Final Recommendation Report

City of Wildwood Planning and Zoning Commission

January 17, 2017 Executive Meeting

Petition Numbers: *P.Z. 12 and 13-15 The Villages at Bright Leaf*

14.5 ft. EMERGENCY ACCESS DRIVE
N.T.S.

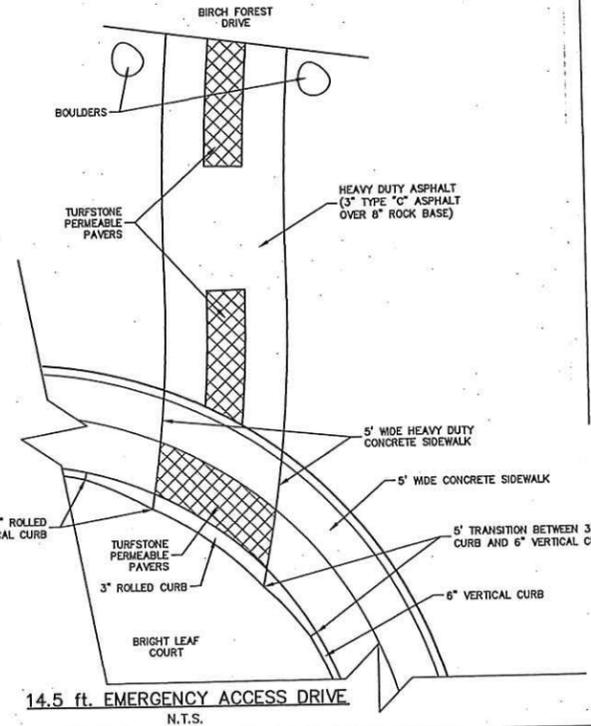
3. The selection of the best method to address the secondary emergency access, given the fire district's preference for a passive type of approach, while ensuring it does not become an issue for pedestrians and bicyclists to use. Other considerations of the fire district needing to be addressed as well include the following: roundabout, splitter island, and speed table designs. **Commission's Note >>>** The developers have provided a revised design for this planned connection to serve as secondary emergency access and a pedestrian way between the new development and the Evergreen Subdivision, which includes a mix of materials, design components, and landscaping to create a useable passageway for emergency vehicles and pedestrians, while discouraging any other use. The design is provided in an attached sheet. The Commission supports this design, which includes, at this time, a mix of asphalt and turfstone permeable pavers to provide the required stable surface for emergency vehicles and other users. The selected permeable pavers allow for grass to germinated and grow within the voids associated with its pattern, so as to provide a green space in this area. Complementing this access way, landscaping and boulders are planned along its edges. Although the Commission is supportive of this design, it does believe the entire area should be constructed with the turfstone permeable paver material, so as all of it will be a grass area capable of accommodating the weight of emergency vehicles and other users. This area being turf will also have a better visual appearance to surrounding lot owners and deter others from its use, since no type of gate or bollard system is planned at this time.
